BERGER 6S

PLUG AND ABANDONMENT

Current Schematic - Version 3

<Ward.Rikala@emnrd.nm.gov>; Rennick, Kenneth G <krennick@blm.gov>; Kade, Matthew H <mkade@blm.gov>
Cc: Farmington Regulatory Techs <FarmingtonRegulatoryTechs@hilcorp.com>; Clay Padgett <cpadgett@hilcorp.com>;
Lee Murphy <lmurphy@hilcorp.com>; Rustin Mikeska <rmikeska@hilcorp.com>; John LaMond <jlamond@hilcorp.com>;
Matt Gustamantes - (C) <Matt.Gustamantes@hilcorp.com>
Subject: [EXTERNAL] P&A Revision Request for Hilcorp's BERGER 6S (API # 3004532947)

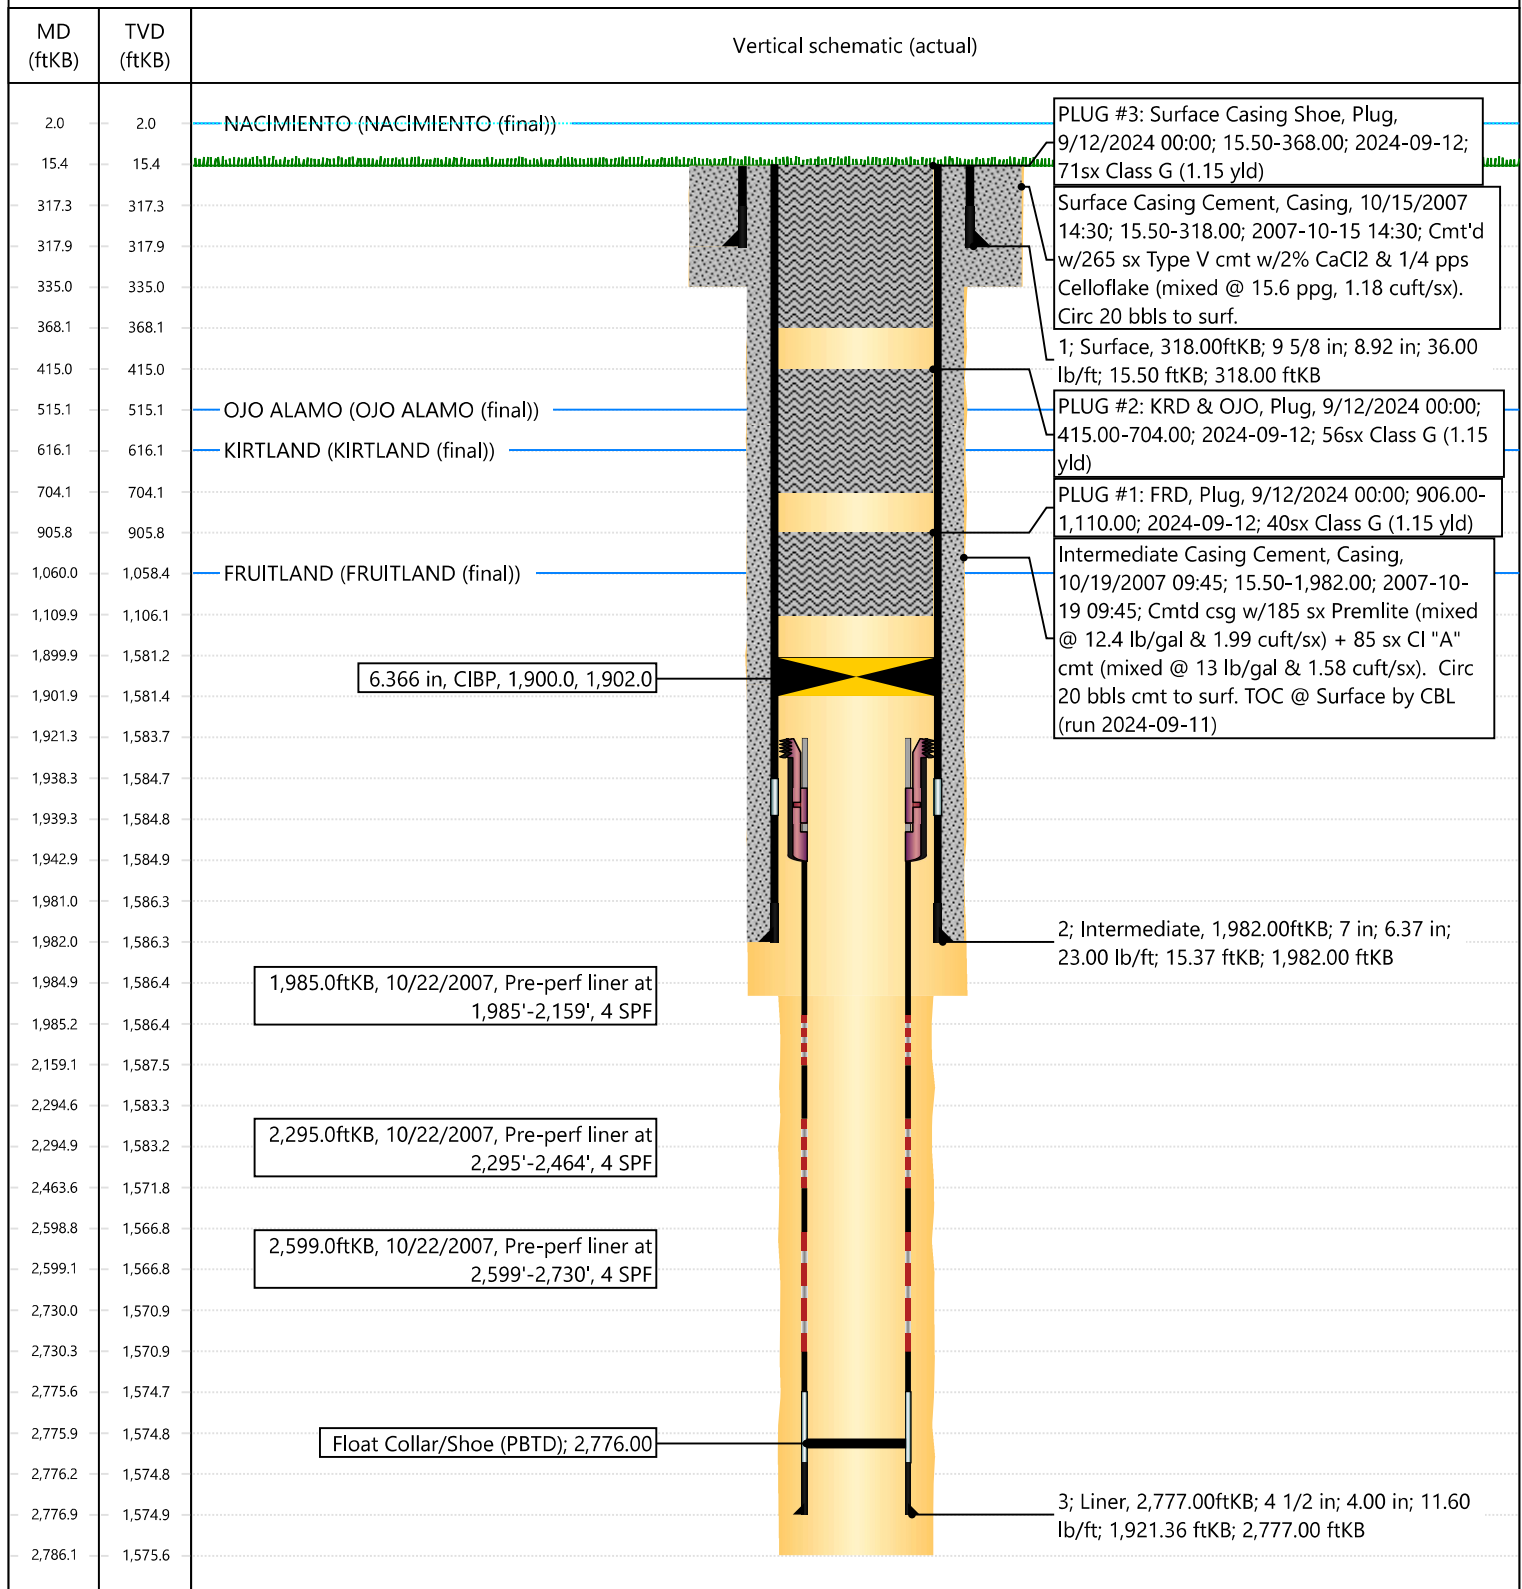
Created By	Condition	Condition Date
mkuehling	This is a horizontal well - schematic does not show it - well plugged 9/12/2024	10/2/2024
